Wisconsin Department of Transportation

Proposal #29: 2025-03-73, WISC 2025600
C Brookfield, Capitol Dr
Brookfield RD to 124th St
STH 190
Waukesha County

This is Addendum No. 01, which provides for the following:

Addendum No. 01
ID 2025-03-73
Revised Sheet 15
September 30, 2025

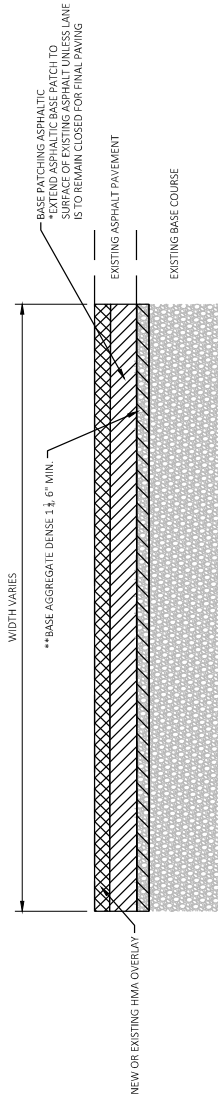
Revised Plan Sheets	
Plan Sheet	Plan Sheet Title (brief description of changes to sheet)
15	Revised note under triple asterisks to state that the additional 6 inches of aggregate base removal will be paid for under bid item Removing Pavement for Base Patching.
476	Revised the MQ table for bid item Asphaltic Surface Patching to reduce the quantity to 25 tons.

- * UPPER LAYER AUNT 58-28.5 IS INCIDENTAL TO THE BASE PATCHING ASPHALTIC ITEM
- ** BASE AGGREGATE DENSE 1 1/2" PAID UNDER SEPARATE BID ITEM. ONLY REQUIRED FOR BASE PATCHES FOR LOOP
- *** THE ADDITIONAL 6 INCHES OF AGGREGATE REMOVAL REQUIRED FOR LOOP DETECTOR INSTALLATION WILL BE PAID FOR UNDER BID ITEM REMOVING PAVEMENT FOR BASE PATCHING.
